Product / Process Change Notification (PCN)

<p>PCN Number: PCN_ConPSHD_20241213</p> <p>Affected Series: WR-PSHD</p> <p>Affected Order Codes: 610106249121 ; 610108249121 ; 610110249121 ; 610112249121 ; 610114249121 ; 610116249121 610120249121 ; 610122249121 ; 610124249121 610126249121</p> <p>PCN Date: 2024-09-13 (YYYY-MM-DD)</p> <p>Effective Date: 2024-12-13 (YYYY-MM-DD)</p>	<p>Change Category:</p> <p><input checked="" type="checkbox"/> Equipment/Location <input type="checkbox"/> General Data <input type="checkbox"/> Material <input type="checkbox"/> Process <input type="checkbox"/> Product Design <input checked="" type="checkbox"/> Shipping/Packaging <input type="checkbox"/> Supplier <input type="checkbox"/> Software</p>
<p>Contact: Product Management</p> <p>Phone: +49 (0) 7942 - 945 5001</p> <p>Fax: +49 (0) 7942 - 945 5179</p> <p>E-Mail: pcn.eican@we-online.com</p>	<p>Datasheet Change: <input checked="" type="checkbox"/> Yes <input type="checkbox"/> No</p> <p>Attachment: <input type="checkbox"/> Yes <input checked="" type="checkbox"/> No</p>

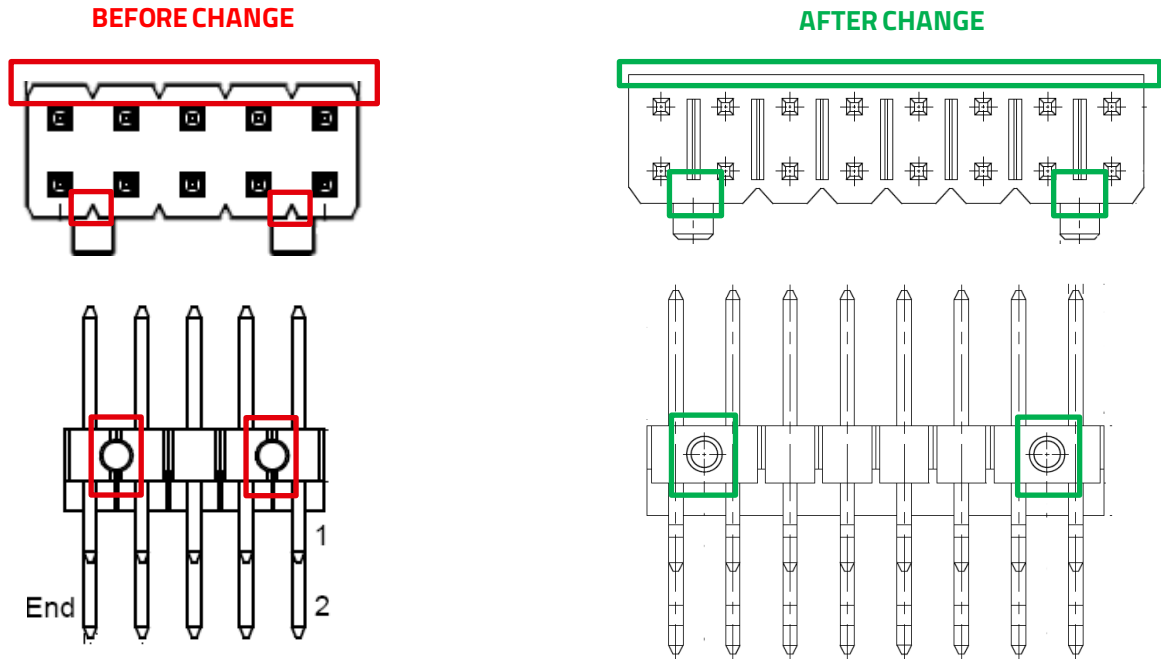
Due to an improvement of the production capability, Würth Elektronik eiSos will change the injection mold of the plastic housing. This implies a few cosmetic changes on the housing. Packaging specifications for 610106249121 will also be updated.

Cosmetic changes on the housing

For 610106249121:

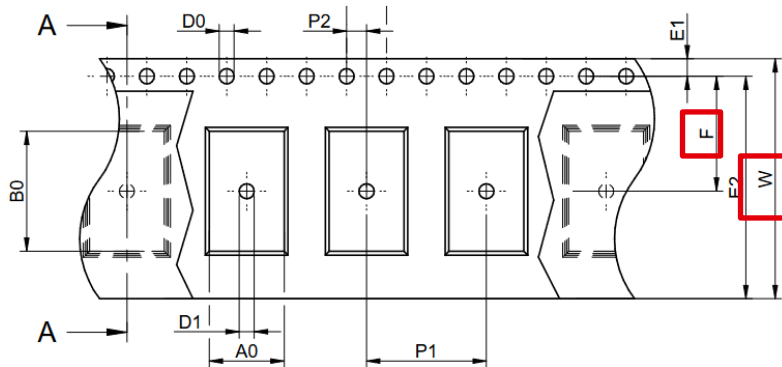
W (mm)	F (mm)	Parts / reel (SPQ)	Quantity / carton
BEFORE CHANGE	24	11.5	9	3150
AFTER CHANGE	16	7.5	12	4200
